# Report of the CAA's Post Implementation Review of the London Airspace Management Programme (LAMP) Phase 1A Module C Airspace Change Proposal – London City Network Changes

CAP 1692 C

This report is part of a series of PIR reports for LAMP Phase 1A Airspace change proposal implemented on 4 February 2016.

## Worthing CTA (South) Option 2 Possible Revision to NATMAC Proposal

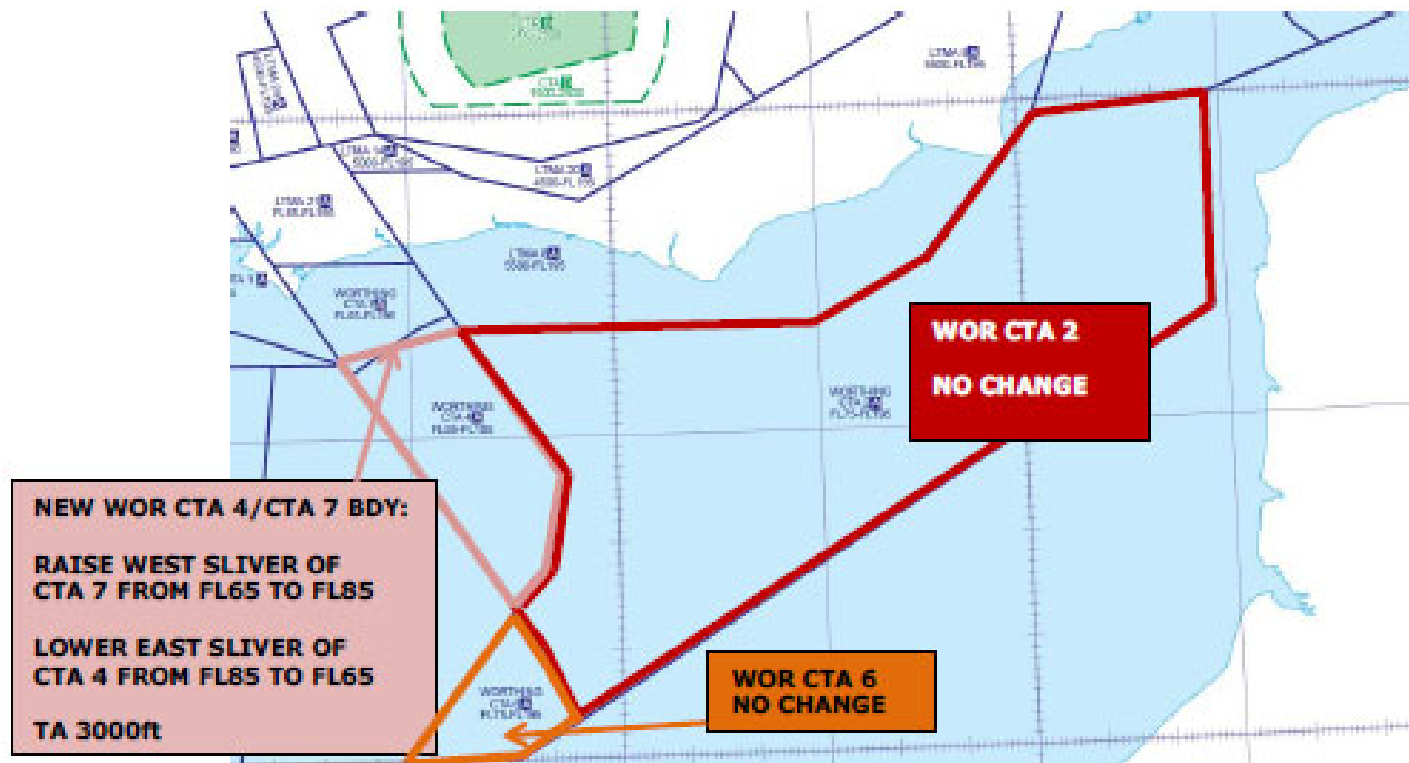
- Outcome of CAA review of NATS analysis 31 Aug 16:
- Some lower limits could be raised
- Very small window of opportunity for implementation on 2 Mar 17
  - Needs decision by 1 Nov 16 otherwise 1 year delay.
- Objectives:
  - Raise CAS if not required
  - Simplify airspace structures where possible
  - Reduce chart / label clutter
  - Reduce risk of infringements
  - Opportunity to smooth out a few lateral boundaries

- CAA action arising from outcome of NATMAC feedback:
- Confirm any outstanding NATMAC feedback due in today
- Any further queries, objection, or support?
  - Seek Group Director SARG approval, then ratify with NATS
  - Confirm AIP amendments can be processed in time
  - Prepare AIC
  - Seek ICAO agreement
- If any show stoppers, then proposals delayed 1 year or withdrawn
